D3016-041 SEAT FRAME ASSEMBLY

DRAWING NO. D3016	TITLE SEAT FRAME ASSEMBLY	REV. A	DART AEROSPACE LTD ENGINEERING ORDER	D.E.O. NO. D3016-A-1	SHEET NO. SHEET 1 OF 1	SCALE NTS
DRAWN <i>8</i>	CHECKED <i>UP</i>	MFG. APPR. <i>RE</i>	APPROVED <i>MP</i>	DE APPR. <i>MP</i>		
DATE 10.01.29	DATE 10.01.29	DATE 10.01.29	DATE 10.01.29	DATE 10.01.29	DATE 10.01.29

TO REVISE D3016-11 SADDLE'S HOLE SIZES

D3016-11 SADDLE

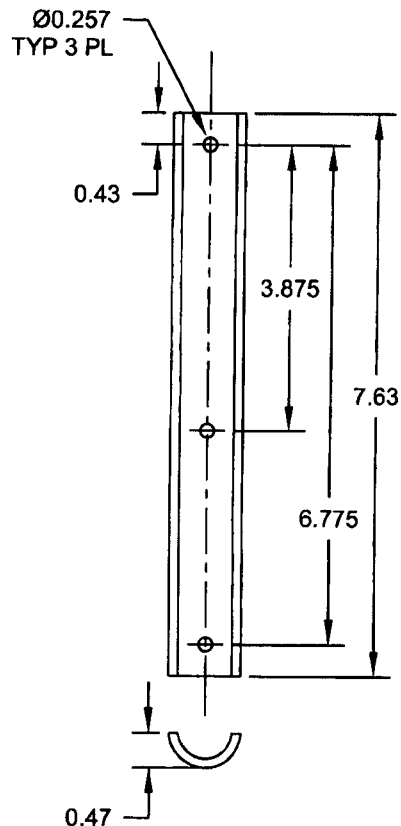
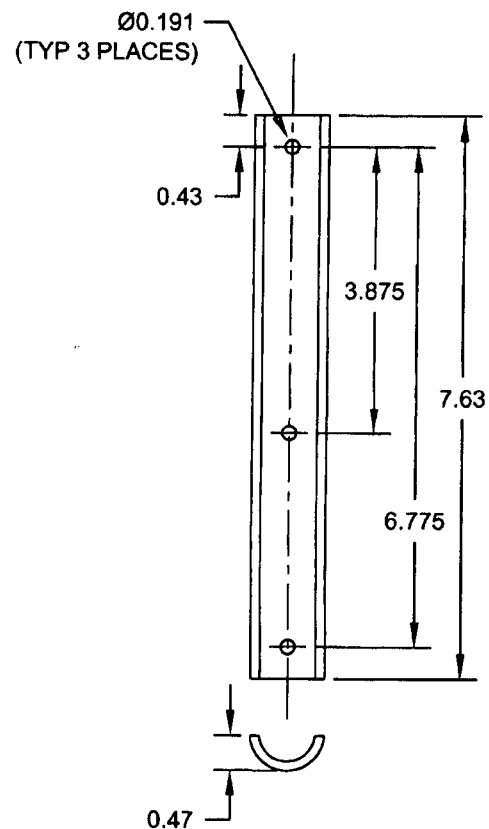
DETAIL D3016-11 SADDLE (SHEET 3): Ø0.257 TYP 3 PL WAS Ø0.191 (TYP 3 PLACES) AS SHOWN:
